DESCRIPTION OF REQUEST: Preliminary/Final Plat Request to subdivide Lot 15-A into two

RE: DRB Project No: 1009243 Preliminary Final Plat Request
Lot 15-A, Block 15, Mesa Grande Addition, To Be Known as 15-A-1 and 15-A-2
Zone Atlas Page K-17-Z

SITE PLAN
LOT 15-A-1 15-A-2, BLOCK 15
MESA GRANDE ADDITION

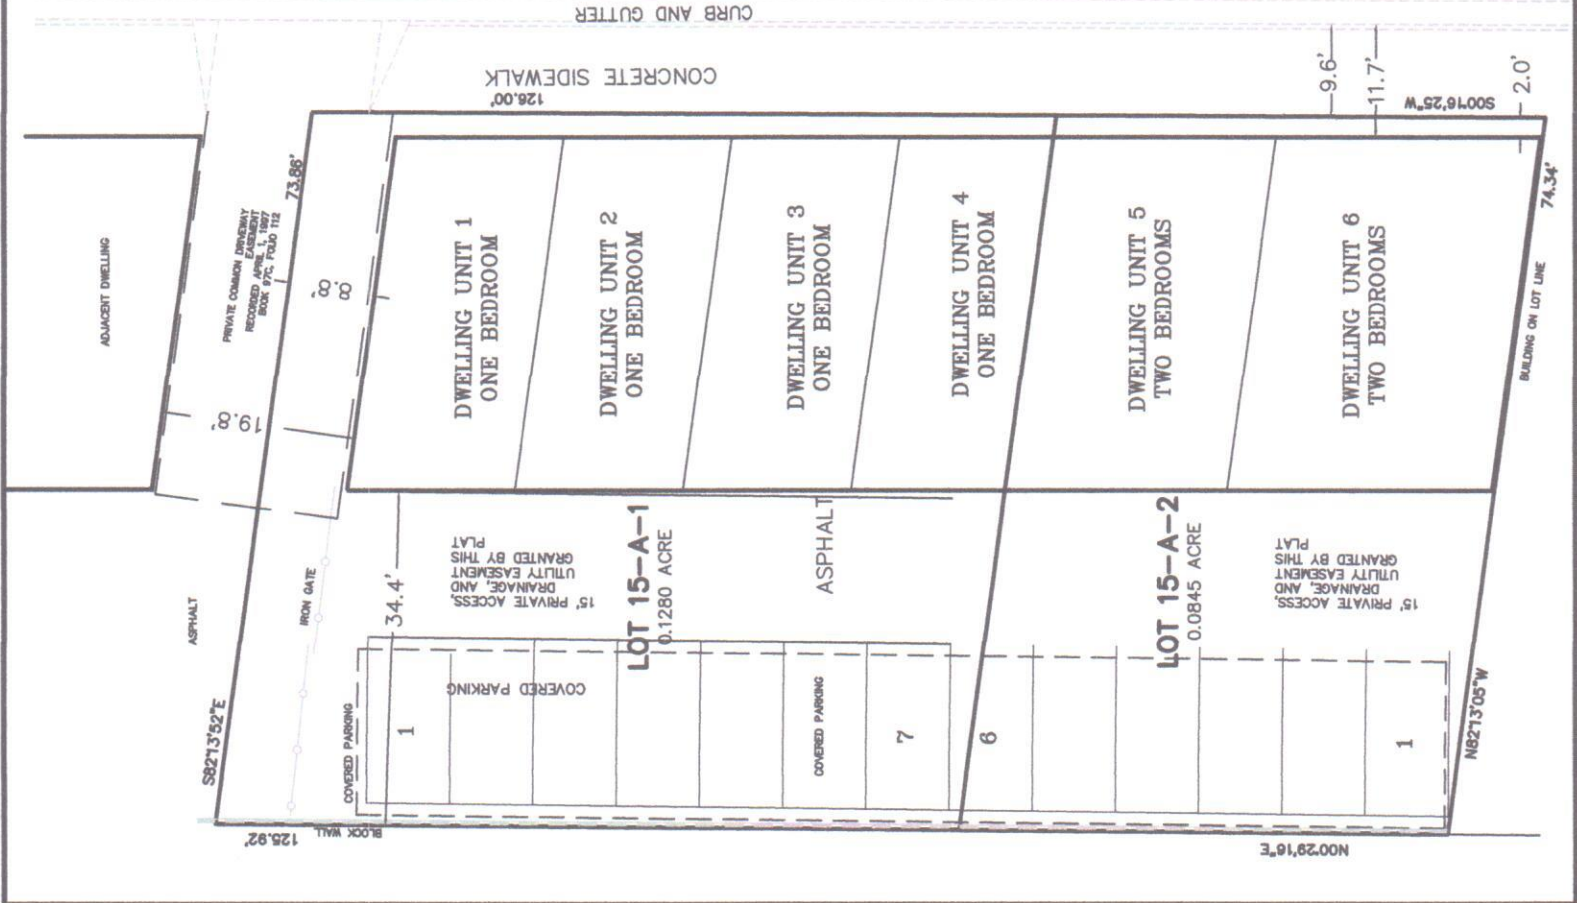
Below is answer to your comments from sketch plat.

- 1) Attached please find a copy of the recorded plat showing the access easement between Lot 15-A and Lot 17-A.
- 2) Per Nob Hill/Highland Sector Plan the parking requirement is 1 space per bedroom or 1.5 spaces per 2-bedroom unit. Lot 15-A-1 requires 4 parking and Lot 15-A-2 requires 3 parking. As you can see the existing parking for Lot 15-A-1 are 7 spaces and for Lot 15-A-2 are 6 spaces. Please see attached site plan for the parking requirements.
- 3) As far as two hour fire wall and covered parking structure, please see attached engineer certification.
- 4) We have also add the beneficiary and maintenance language for the private access, drainage and utility easement. See note No. 13 on the coversheet of the plat.
